**TRANSMITTAL OF DESIGN CHANGE NOTICES FOR THE HAUL ROAD/RELOCATED NORTH ENTRANCE ROAD PROJECT, THE LEACHATE CONVEYANCE SYSTEM PROJECT, AND THE ON-SITE DISPOSAL FACILITY PROJECT**

**Design Change Notice (DCN) Report for On-Site Disposal Facility (OSDF) - Phase I  
Subcontract No. FY 597**

Page 2 of 5  
DEN No. 1703-004  
949

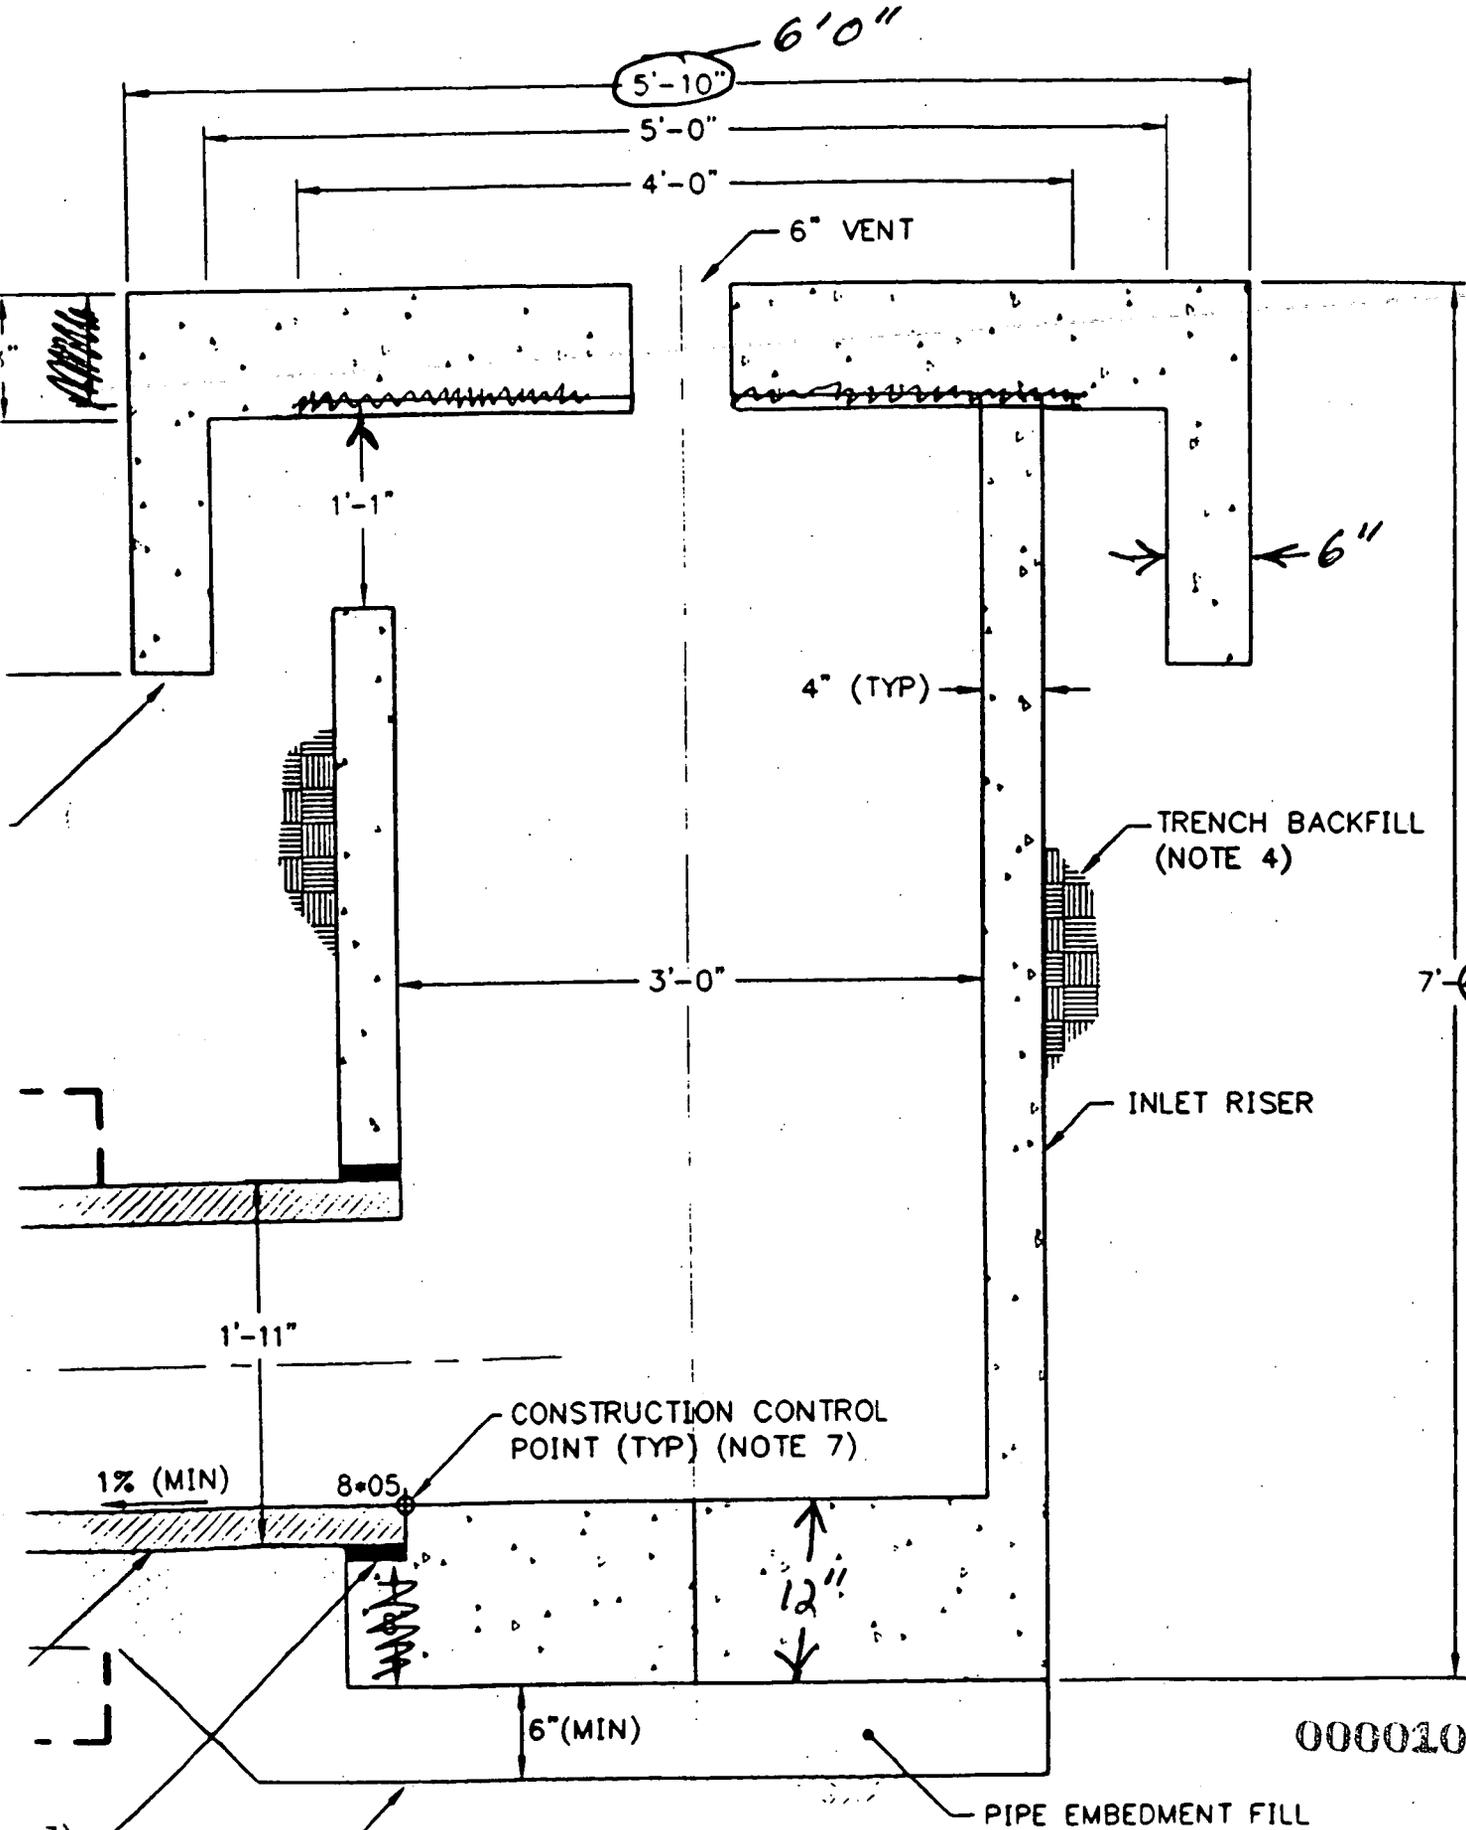
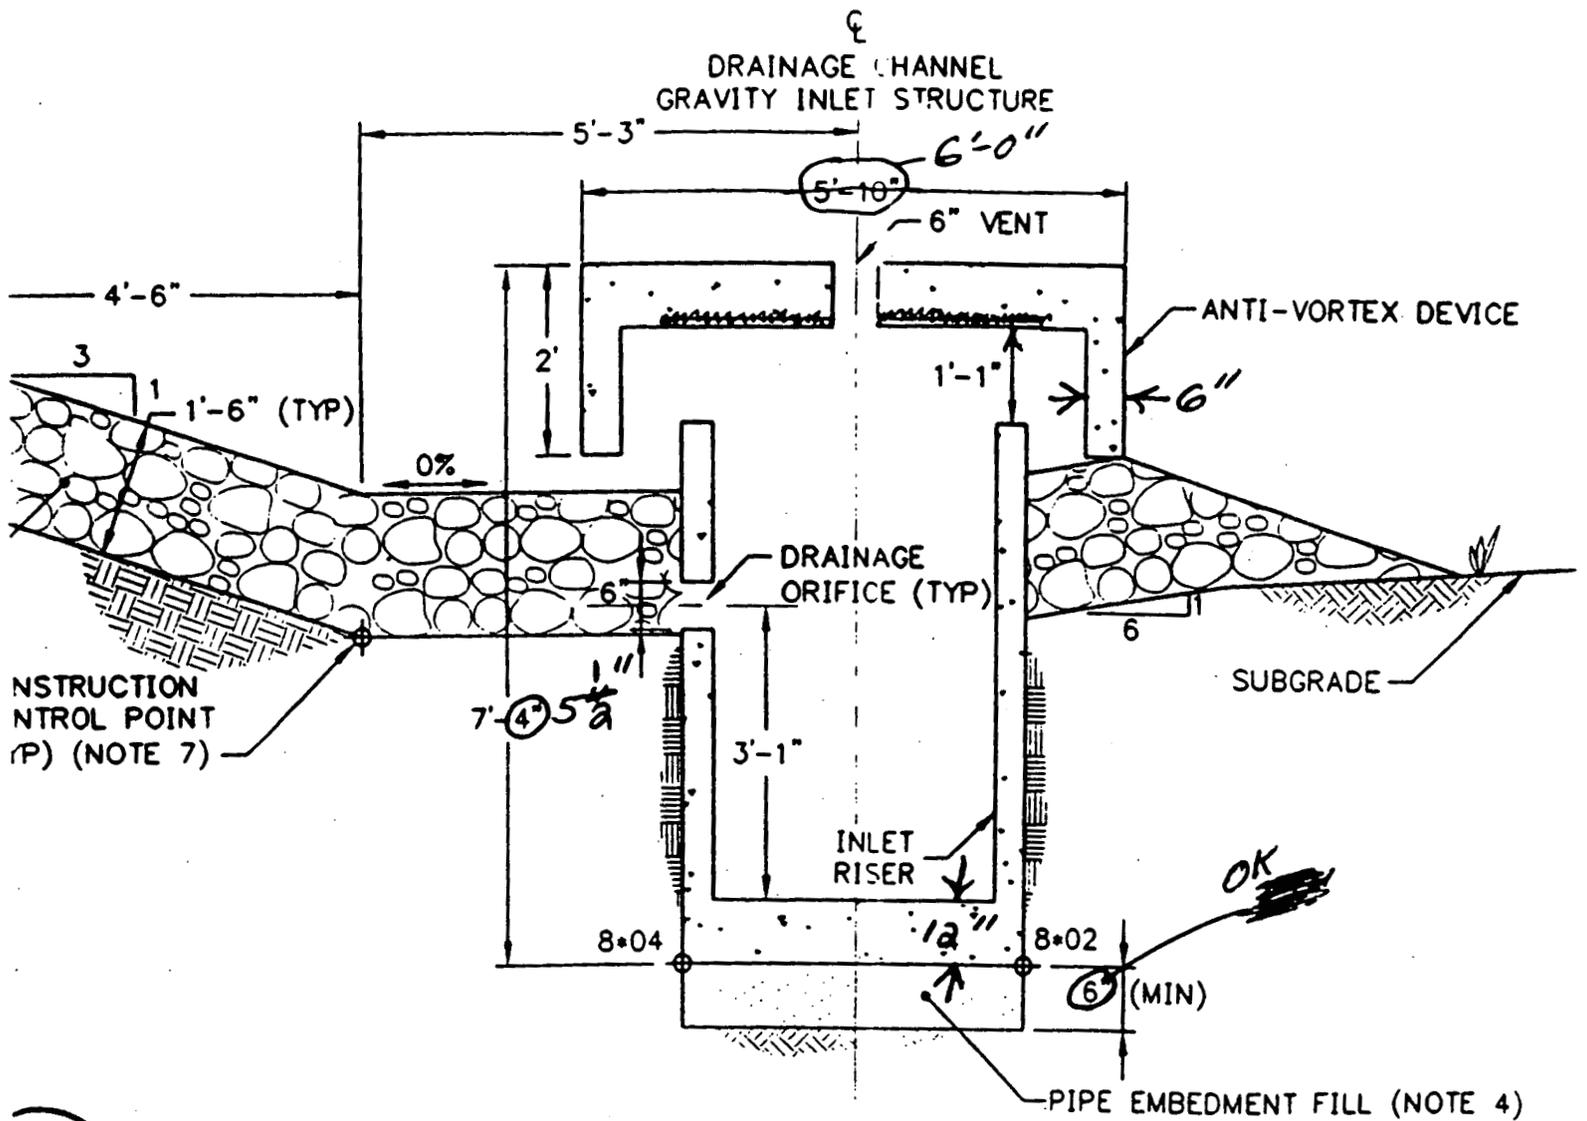
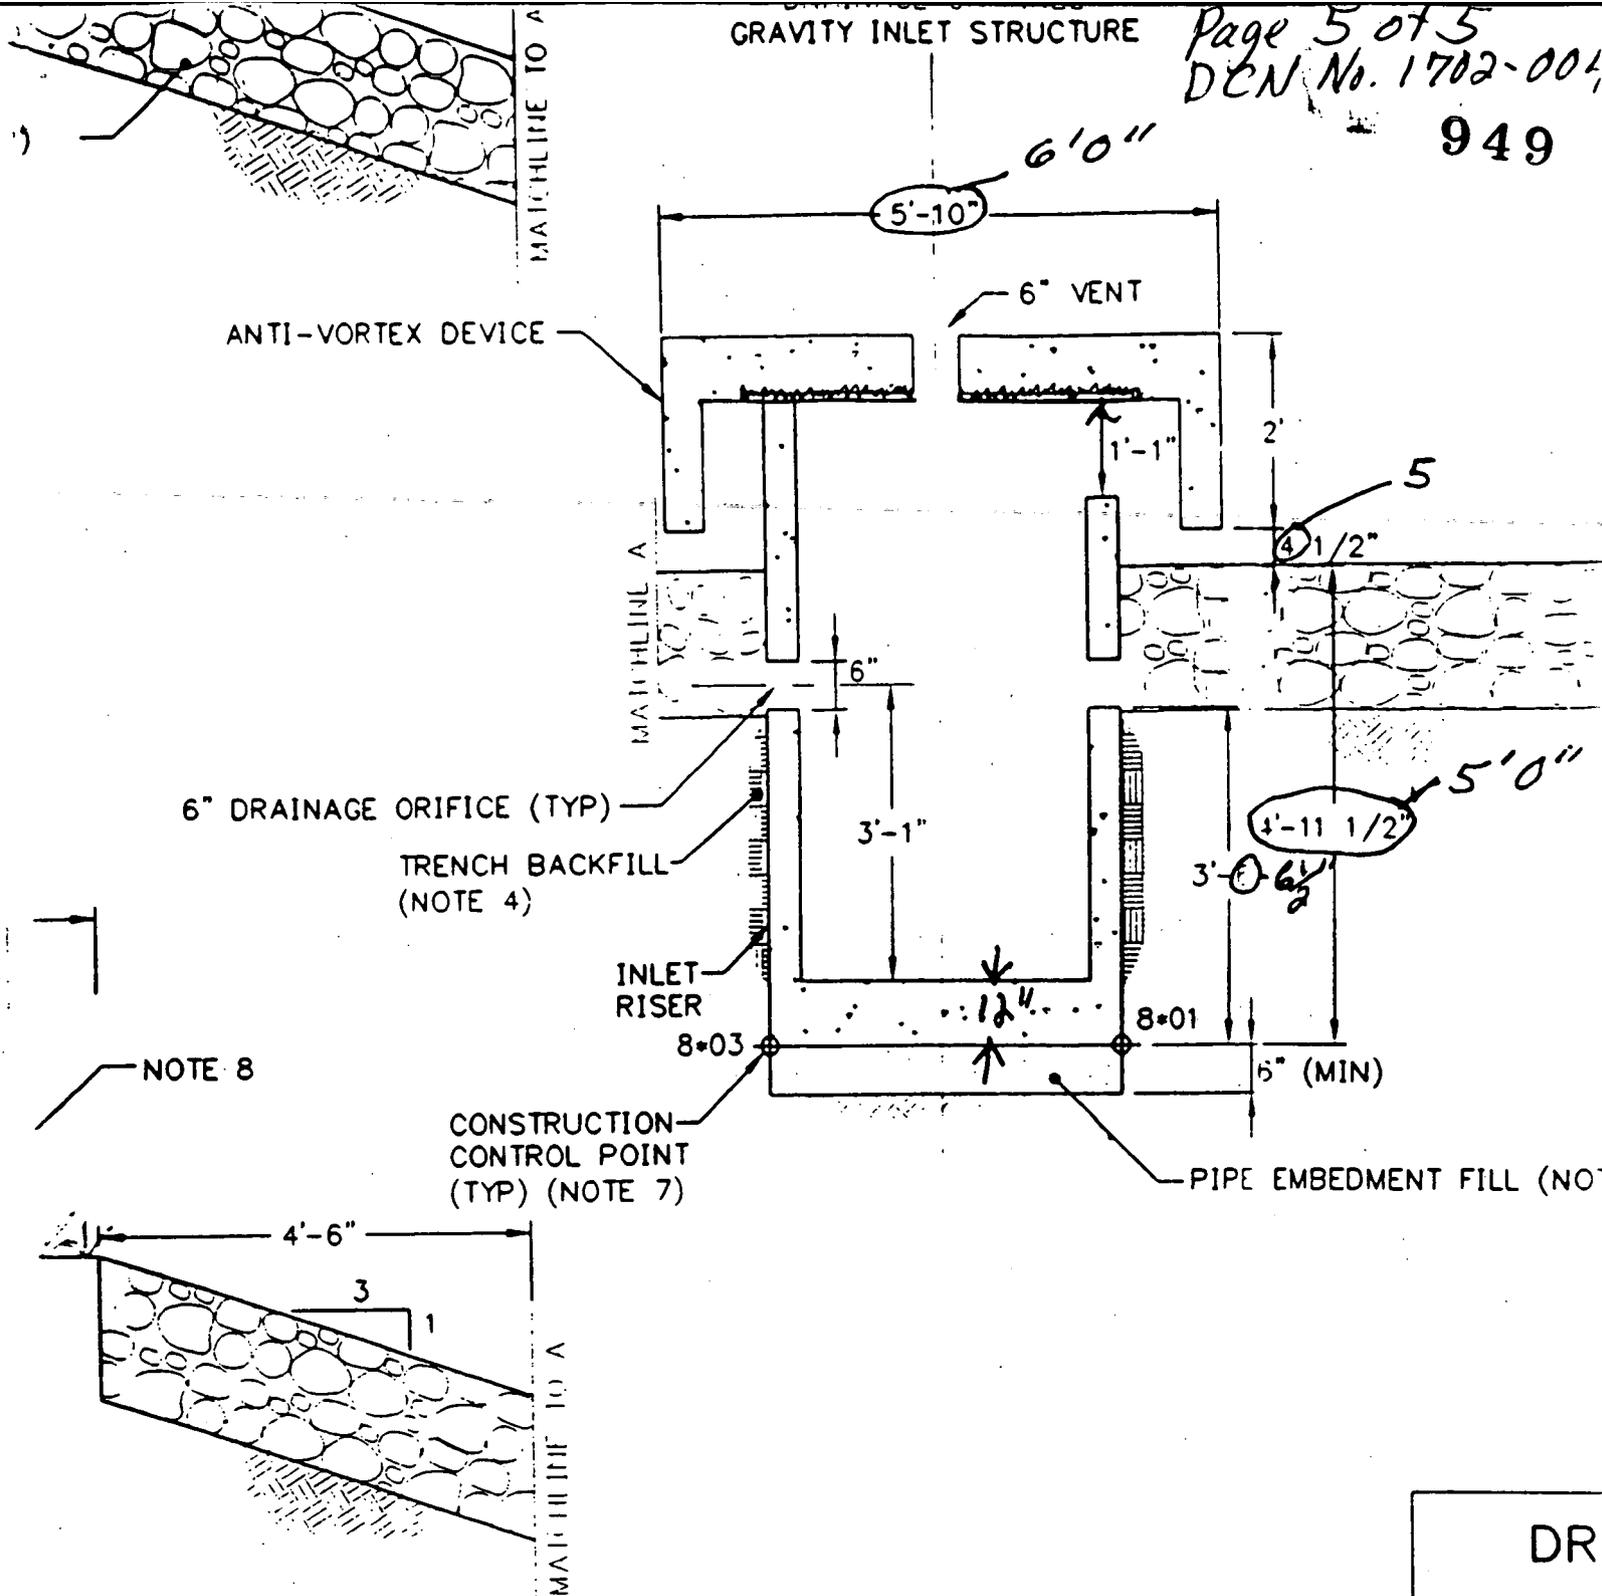
CONSTRUCTION CONTROL POINTS ASSOCIATED WITH DRAINAGE CHANNEL GRAVITY INLET STRUCTURES ARE

SK-20110-003  
11/5/96  
J.C.J.

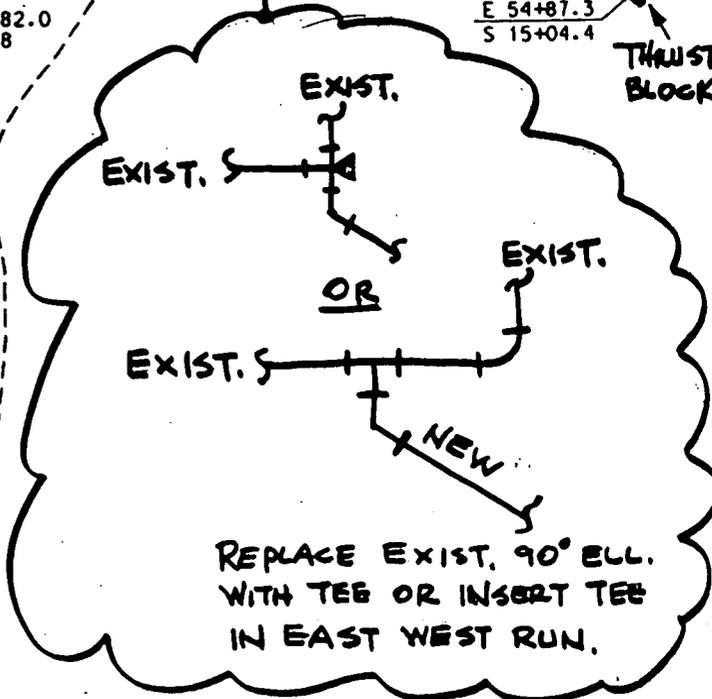
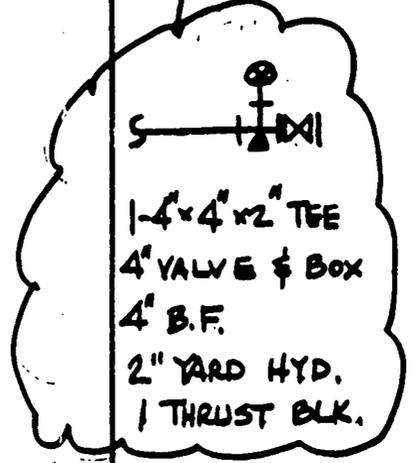
BLDG. 31 & 46, AREA 16 YARD AREA  
 GRID 7  
 UNDERGROUND UTILITIES  
 SCALE 1"=20'  
 1700-001  
 Page 2 of 4

~~SK-20110-003 REV 1 12-09-96  
J.S.~~

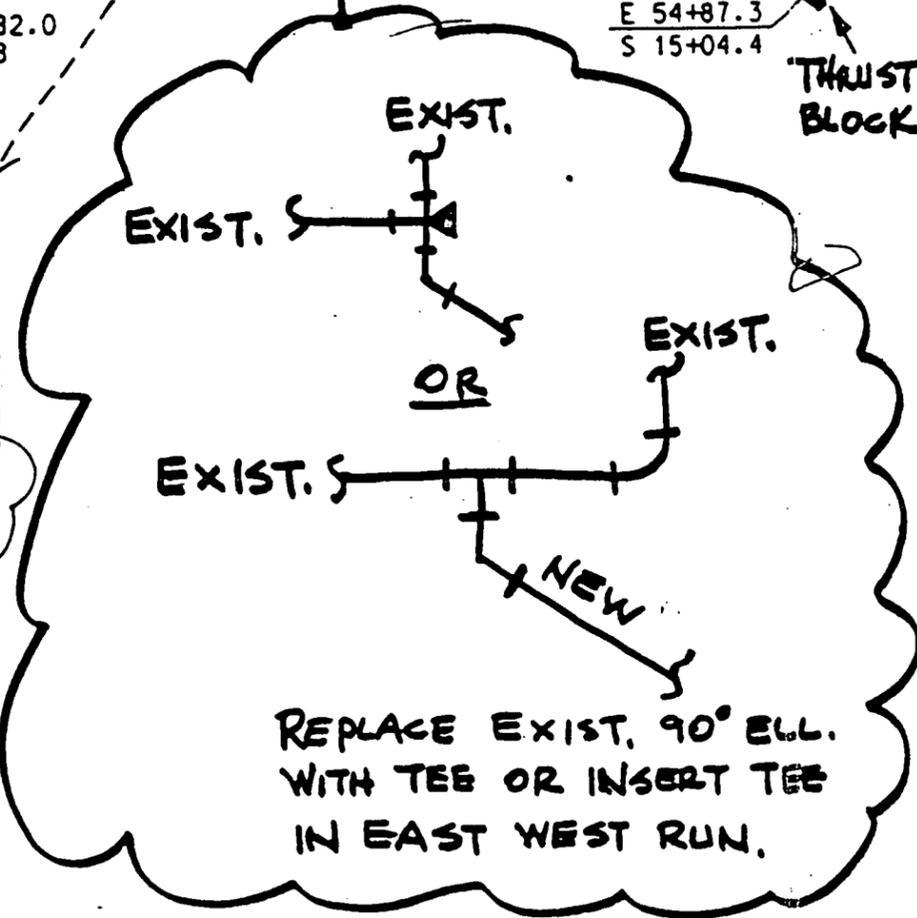
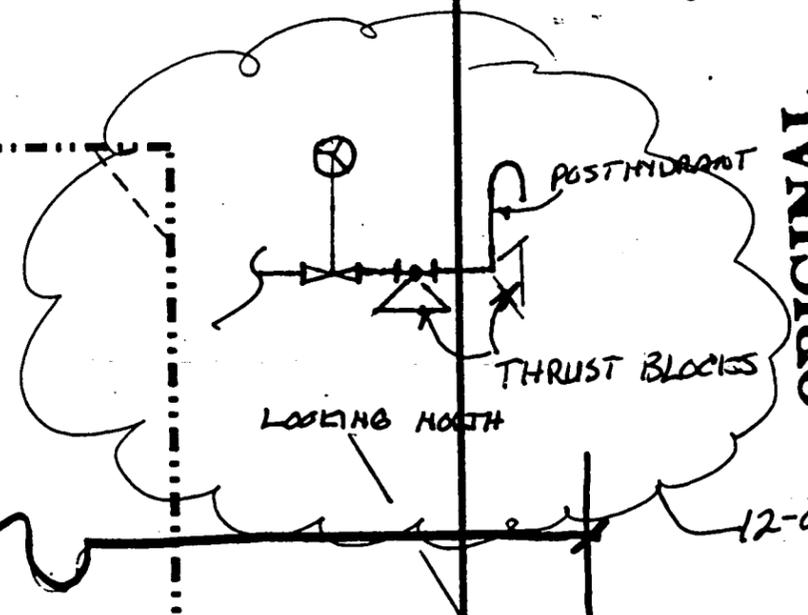
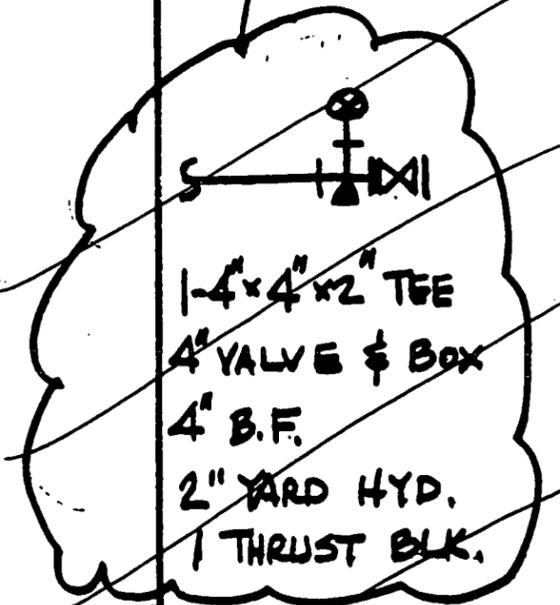
NEW DW-4" PVC 18" BELOW GRADE

SK-20110-005

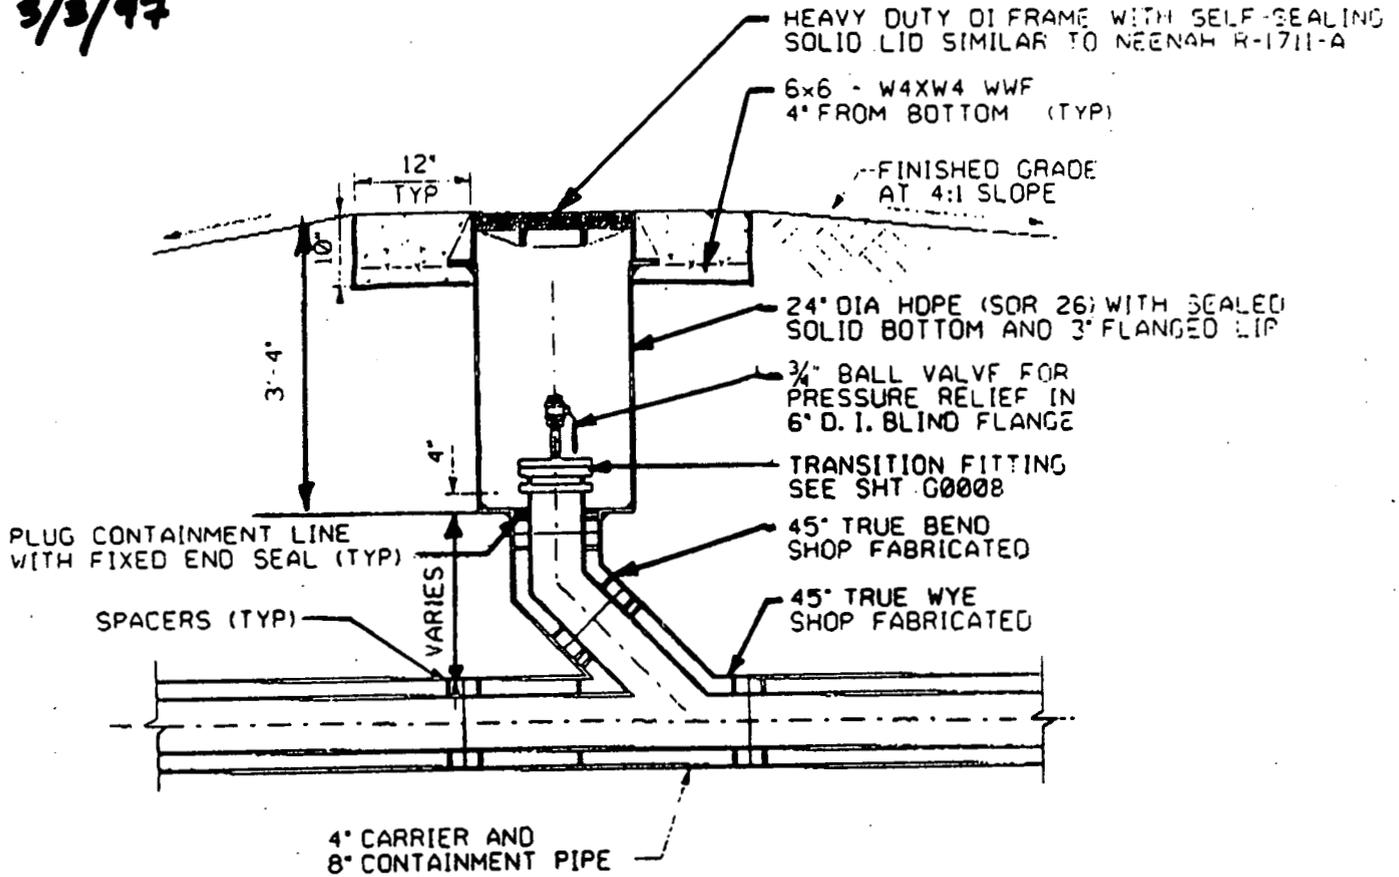
(9) RCI - INQUIRY [ ] USOD SCREENING BY PROJECT ENGINEER [ ] (9) DCN JUSTIFICATION, EXISTING CONDITION & REQUESTED/PROPOSED CHANGE. All C.O.'s are housed in manholes with access frames & covers. Propose to eliminate all C.O. manholes except nos. 1, 4, 5, & 11 and replace with cleanout as shown on attached sketch. SK-20110-005. Carbon steel piping and appurtenances are also deleted from the respective manholes. Change SDR of M.H.'s 1, 4, 5, and 11 from 32.5 to 26 to expedite delivery.

- CLEANOUT ASSEMBLIES SHALL BE SHOP FABRICATED. ALLOW FOR FIELD CONNECTION TO PIPELINE.
- THE DIMENSION FROM TOP OF FRAME TO TOP OF CONTAINMENT PIPE VARIES FOR EACH CLEANOUT.
- INSTALL CLEANOUT ON LATERAL FOR COMH 10 AND COMH 12 LOCATIONS. USE ALL 4"/8" HDPE PIPE, BEND, AND WYE SIMILAR TO THE TYPE 3 PLAN ON DWG G00258.
